Item 4.**Development Application: 5-7 Bourke Road, Alexandria – D/2018/1208****File No.:** D/2018/1208**Summary**

Date of Submission:	5 October 2018 Amended plans and additional information received on 27 November 2018, 25 February 2019 and 1 April 2019.
Applicant:	Mr Alan Yazbek
Architect:	Candalepas Associates
Developer:	Infinity Construction Group
Owner:	Orfanos Investments Pty Ltd, Maxso Pty Ltd and Alan Yazbek Investments Pty Ltd
Cost of Works:	\$15,722,457.30
Zoning:	The site is zoned B7 Business Park. The proposed development is defined as 'commercial premises' and is permissible with consent in the zone.
Proposal Summary:	<p>The concept (stage 1) development application (DA) seeks consent for a commercial building envelope up to 35 metres in height (accommodating approximately nine storeys) and removal of two street trees. The proposed indicative uses comprise office premises, ground floor shop and above ground car parking.</p> <p>The application is referred to the Local Planning Panel for determination as a Public Benefit Offer accompanies the application. The Public Benefit Offer is for the dedication of land to Council for footpath widening and for the future Liveable G

Figure 20: Land to be dedication in accordance with the VPA

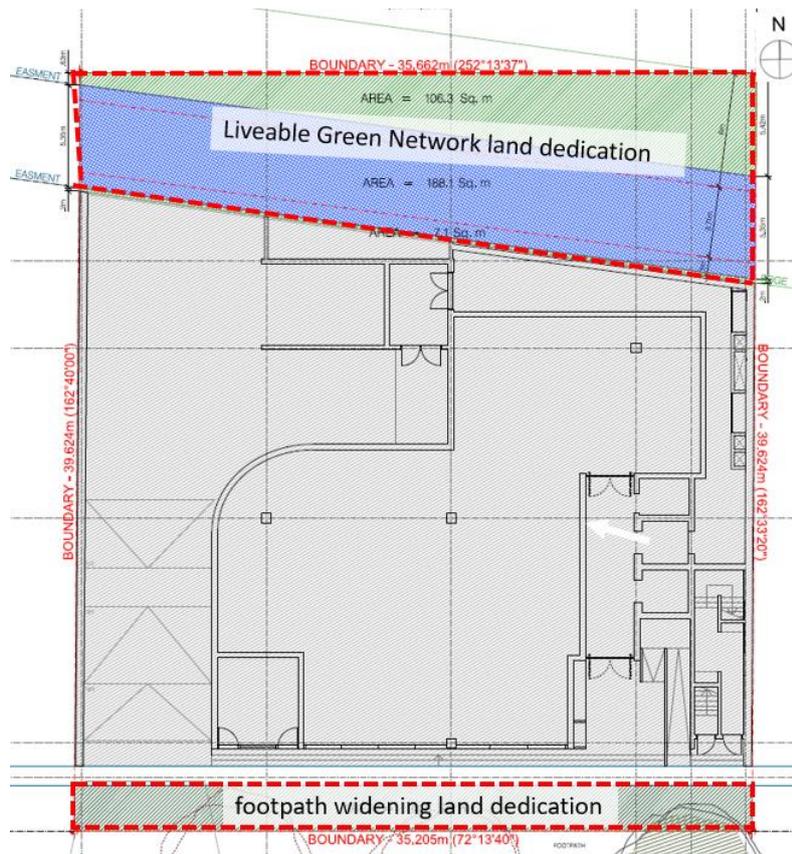
39. A public benefit offer has been submitted with the application. A draft VPA has been prepared based on this offer in relation to the proposal and includes the following public benefits:
- (a) Dedication of land along the Bourke Road frontage of the site for footpath widening. The piece of land is approximately 2.4m wide comprising an area of approximately 84sqm as shown in Figure 20.
 - (b) Dedication of land to the rear of the site for the future Liveable Green Network. The land to be dedicated at the rear has an area of approximately 301sqm.
 - (c) Removal of the slab over the existing stormwater channel, remediation of all land to be dedicated to Council and embellishment works, including landscaping.
 - (d) A monetary contribution of \$210,684.50 towards community infrastructure.

40. The public benefit offer and draft VPA results in the application being able to utilise the additional FSR of 1.5:1 under the Green Square community infrastructure provisions contained in Clause 6.14 of SLEP 2012.
41. The draft VPA was publically exhibited for a period of 28 days between 6 May 2019 and 3 June 2019 in accordance with the Environmental Planning and Assessment Regulation 2000. At the time of writing this report, no submissions had been received.
42. A deferred commencement consent is recommended requiring the execution of the VPA and registration on title prior to the consent becoming operative.

Figure 21: SDCP 2012 - Height in Storeys map

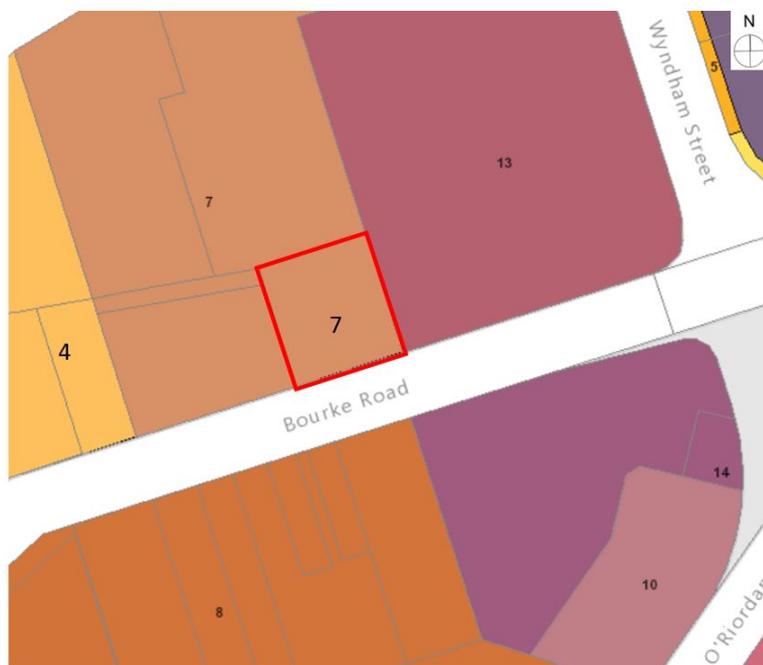
47. The maximum permitted number of storeys permitted under the SDCP 2012 is seven and the maximum height permitted under the SLEP 2012 is 35 metres. Figures 21 and 22 show the SDCP 2012 height in storeys map and the SLEP height of building map, respectively.

Figure 23: Proposed section showing compliant floor planning level and ceiling heights within the maximum permitted SLEP 2012 height control

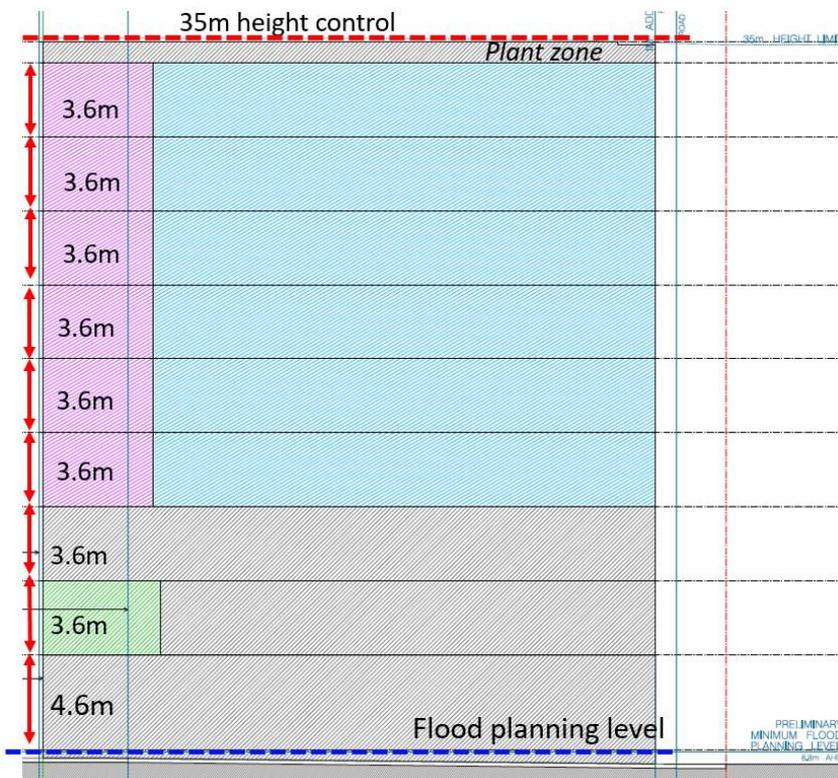
- 48. The reference scheme shows nine storeys being accommodated within the SLEP 2012 height development standard (of 35m). This includes provision of compliant ceiling heights of 4.6m at ground level and 3.6m for the levels above, and the reference scheme shows a compliant flood planning level. However, the envelope has accommodated a minimal zone for rooftop plant and no lift overruns within the maximum 35m height control, as shown in Figure 23:

49. As part of the nine storeys proposed in the building envelope, the proposal includes two levels of above ground car parking. In the reference scheme this accommodates 33 car parking spaces, which is 100% of the maximum car parking permitted for the proposed uses under SLEP 2012. This is contrary to the provisions of Section 5.2.12 of SDCP 2012 which allows up to 50% of car parking to be located above ground only. In this instance, that would be one level of above ground car parking, indicatively shown as accommodating approximately 17 spaces.

50. In order to comply with these above ground parking provisions, the proposal will need to remove one level of car parking. This will reduce the total number of floors within the envelope from nine to eight. A condition of consent is recommended to delete a level of car parking.

51. A development with a total of eight levels, including lift overruns and a 1.6-1.8 metre roof top plant zone behind parapets, will comply with the 35m maximum height control.
